Line of Sight- Existing, Proposed and Recommendation

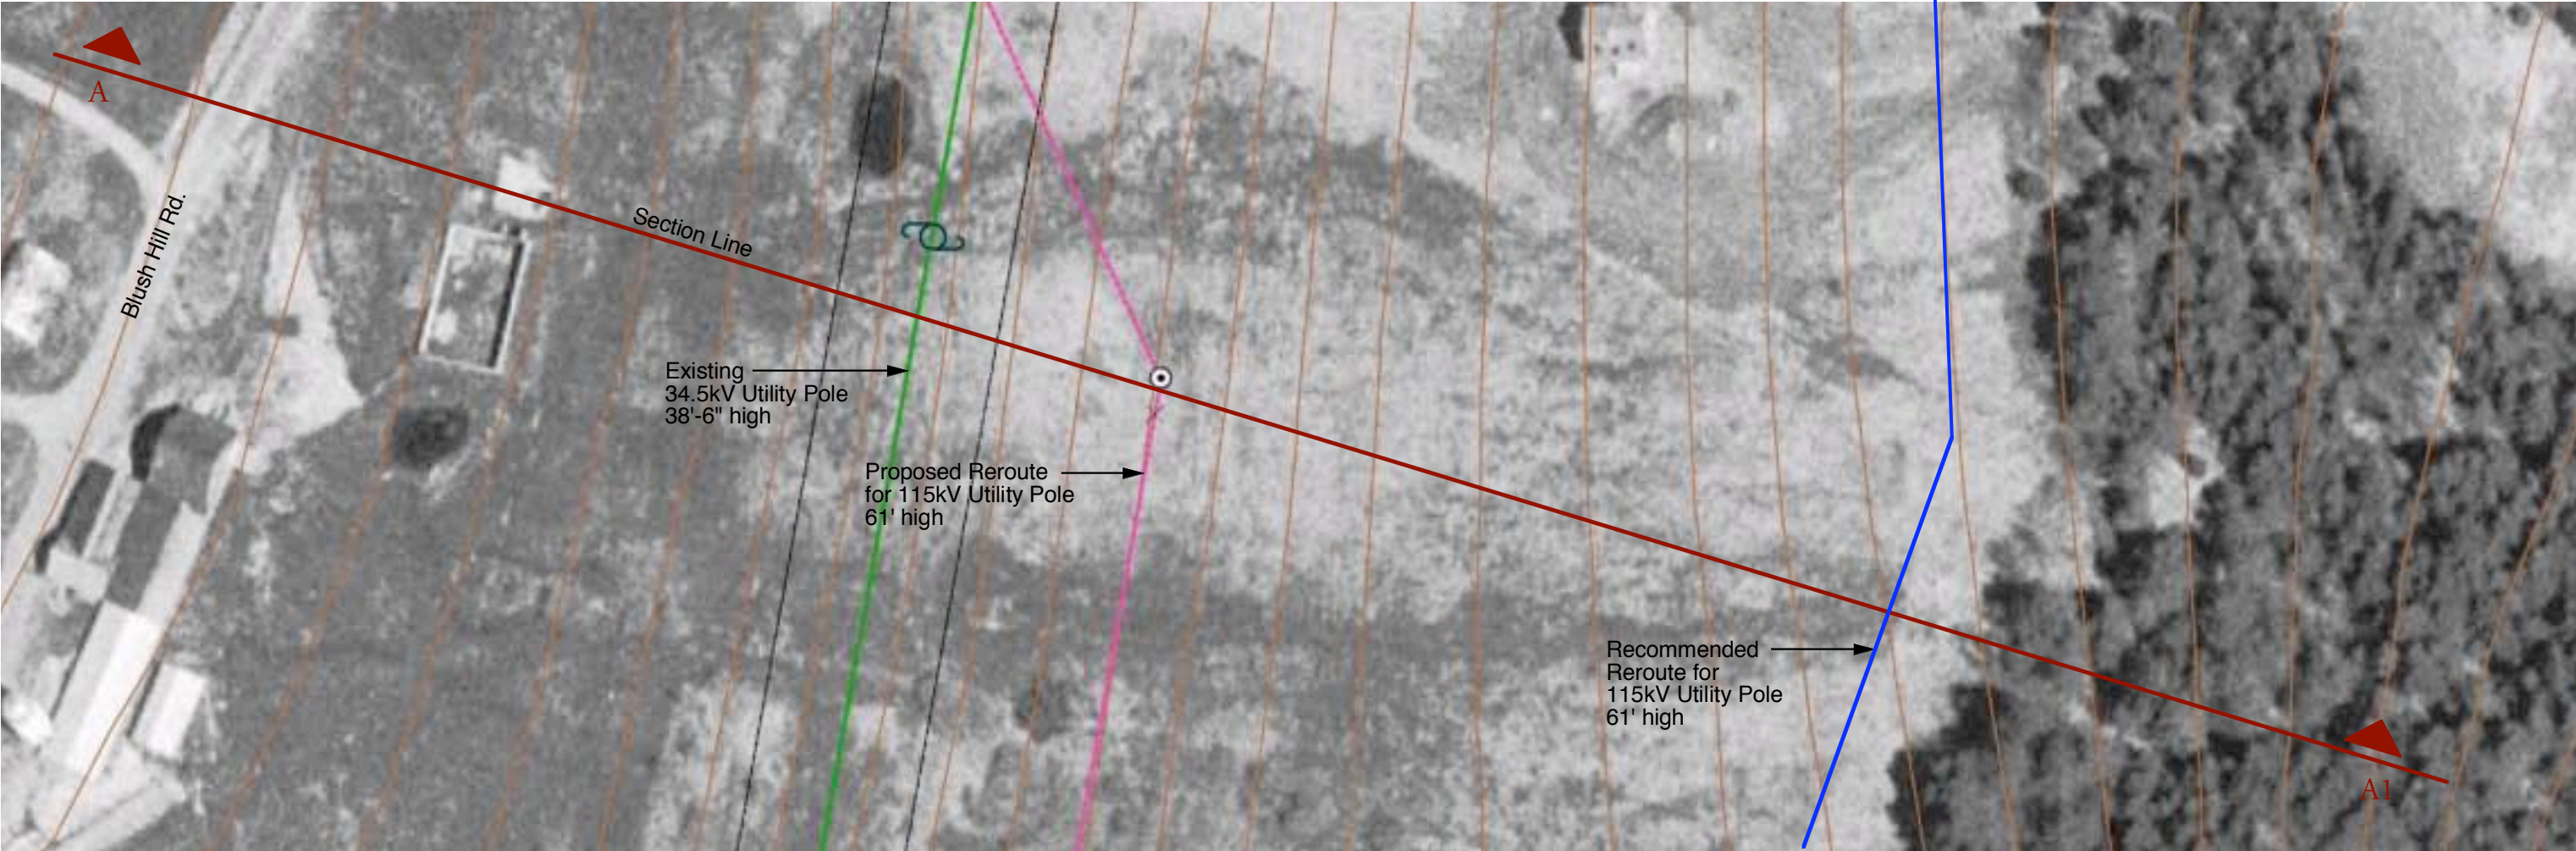
Section A-A1
Scale: 1"=100' This recommended reroute accomplishes two desired results: 1) It takes the poles and conductors out of the viewer's line of sight to the distant landscapes beyond (and the Worcester Mountain Range), thus maintaining scenic qualities; and 2) restores the "intact" quality and integrity of the open space by placing the corridor at the edge, rather than the middle.
